Access Compliance Report Public Rights-of-Way (Curb Ramps)

Main Street: LEAFWOOD_LN		Cross Street: YORBA_ST		Location:	SE
ADA ID: RPAT220222165338	Ramp Type:Type 1 - Perpendicular	Initial Pass/Fail: Pass	Overall Compliance: No	Severity Score:	0
Codes/Mitigation Info/Possible Solution			Field Measurements/Component Compliance

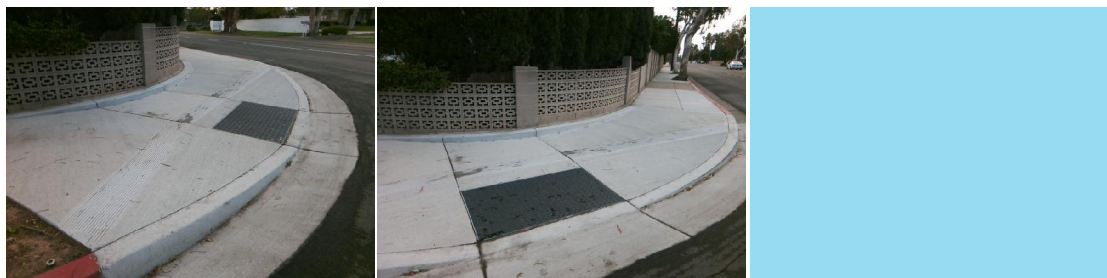
Remove & Replace Landing. Gutter Ponding Observed.

R304.2.1, R304.5.3, R302.7, STD 1115
